WATER RIGHT MAP

FOR RUBY, DUNN
SEC 15, 16, 21, & 22

RE: USER-ID # 10983

With regard to the pump test requirements for the following well and its associated water right:

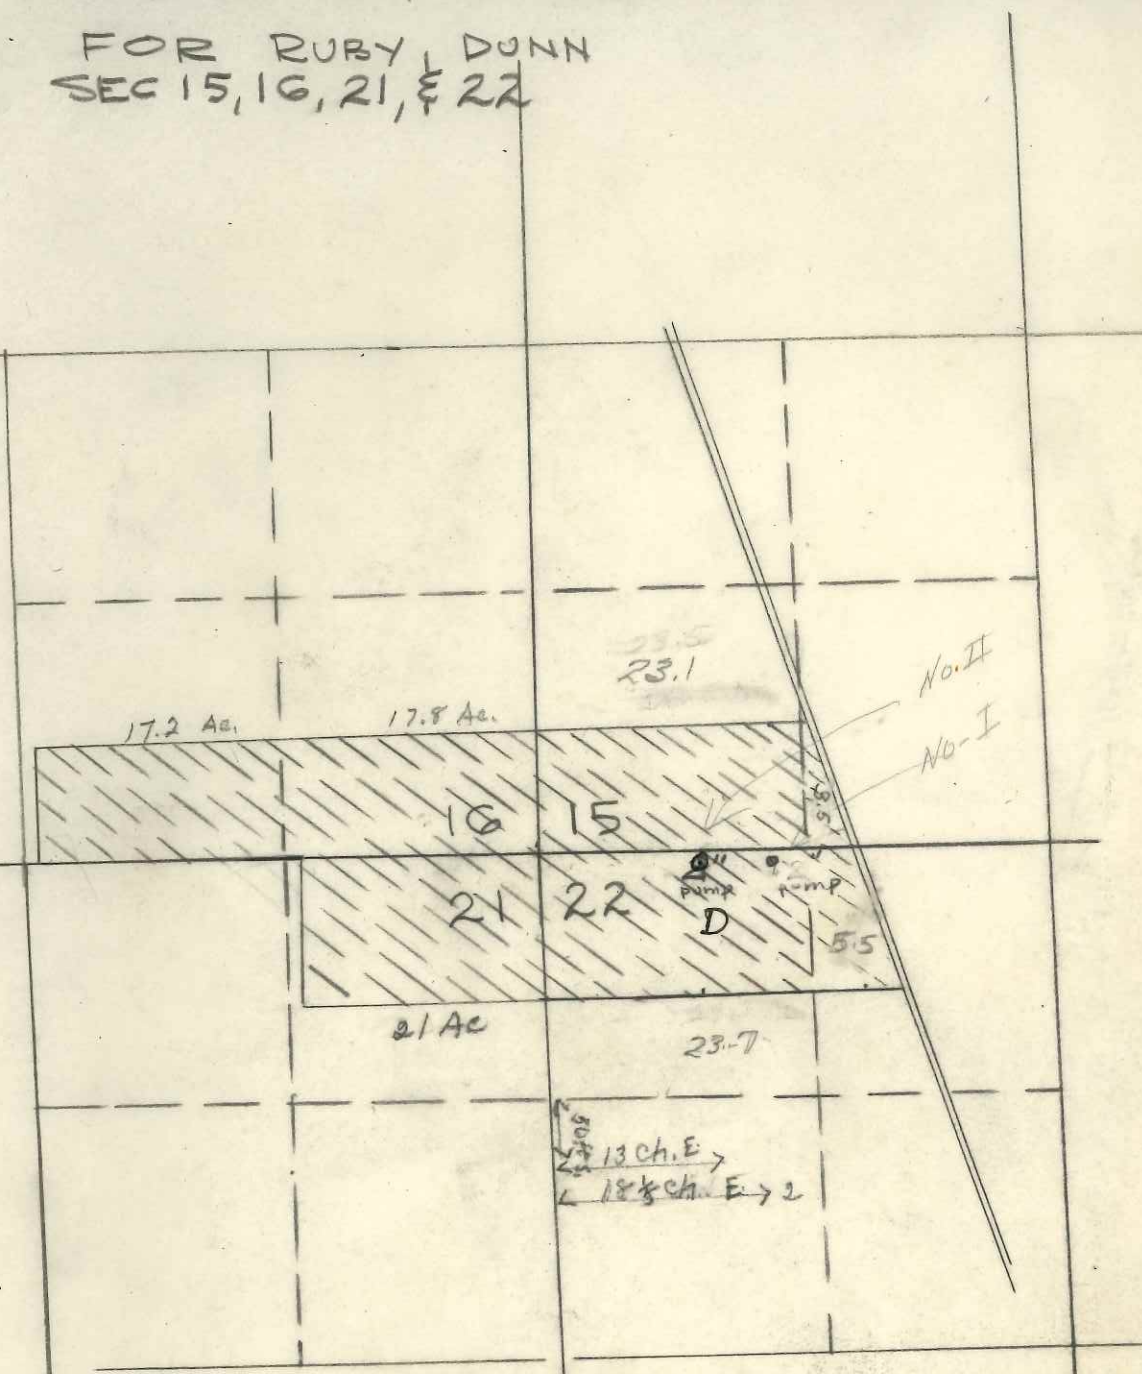
Upon further examination of your application and map, I find the location of your well on your application and on your map does not agree. It appears the well is located 500 feet South and 1600 feet East from the NW corner of Section 22.

To help clarify the overlapping rights, I have prepared a sketch map which shows the rights of record on the land upon which you are filing. Those rights shown in red are covered by certificate 34778. The area cross-hatched in black is covered by certificates GR-2577 and GR-2578. The area outlined in green is the area covered by your application from your well. The wells are also located on the map in corresponding colors.

I am returning your application and map for correction and submission of the legal land description. I am also enclosing our recently revised application form for your use in making these corrections. Your original application must be returned along with the map and new application.
